# Access Compliance Report

## Public Rights-of-Way

### (Curb Ramps)

Intersection ID: 17134	Main Street: CODDINGTON_PL	Cross Street: RANDOLPH_RD	Location: SE
ADA ID: B915F0937B30	Ramp Type: PerpDiag	Initial Pass/Fail: Fail	Overall Compliance: No
Severity Score: 12.5			
Codes/Mitigation Info/Possible Solution		Field Measurements/Component Compliance

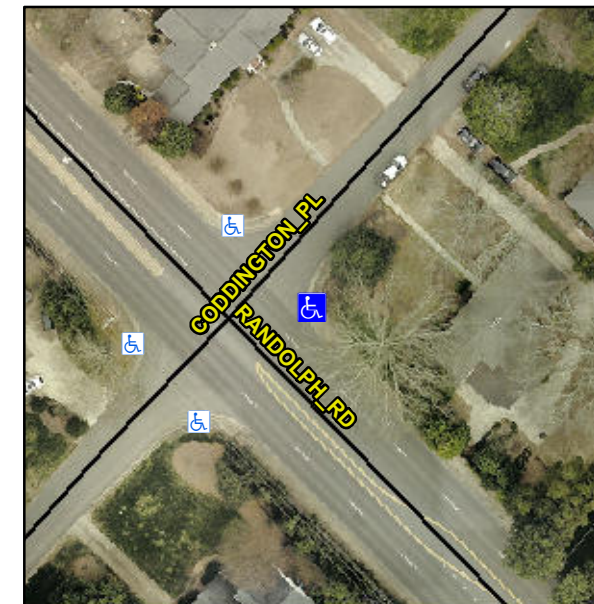
**Not Found, R304.2.2**

Compliance	Description	Data	Compliance	Description	Data
N/A	Ramp Length (in)	48.0	No	Ramp Slope (%)	9.2
Yes	Ramp Width (in)	48.0	Yes	Ramp XSlope (%)	0.5
N/A	Flare Type LT	N/A	N/A	Flare Type RT	N/A
N/A	Flare Slope LT (%)	N/A	N/A	Flare Slope RT (%)	N/A
N/A	Flare Traversable LT?	N/A	N/A	Flare Traversable RT?	N/A
N/A	Landing Length (in)	N/A	N/A	DWS Provided?	N/A
N/A	Landing Width (in)	N/A	N/A	DWS Contrast?	N/A
N/A	Landing Slope (%)	N/A	N/A	DWS Length (in)	N/A
N/A	Landing X Slope (%)	N/A	N/A	DWS Full Width?	N/A
N/A	Landing Curb? (Y/N)	N/A	N/A	DWS Offset (in)	N/A
N/A	Shared Landing?	N/A			
N/A	Gutter Ponding?	N/A	N/A	Gutter Slope (%)	N/A
N/A	Gutter Lip Ht (in)	N/A	N/A	Gutter X Slope (%)	N/A
N/A	Painted X Walk1?	No	N/A	Painted X Walk2?	No
	X Walk 1 Direction	To NW		X Walk 2 Direction	To SW
N/A	X Walk 1 Width (in)	N/A	N/A	X Walk 2 Width (in)	N/A
	X Walk 1 Slope (%)	1.6		X Walk 2 Slope (%)	4.5
	X Walk 1 X Slope (%)	3.7		X Walk 2 X Slope (%)	1.8

**Remove & Replace Curb Ramp With Two New Directional Ramps or Equivalent.**
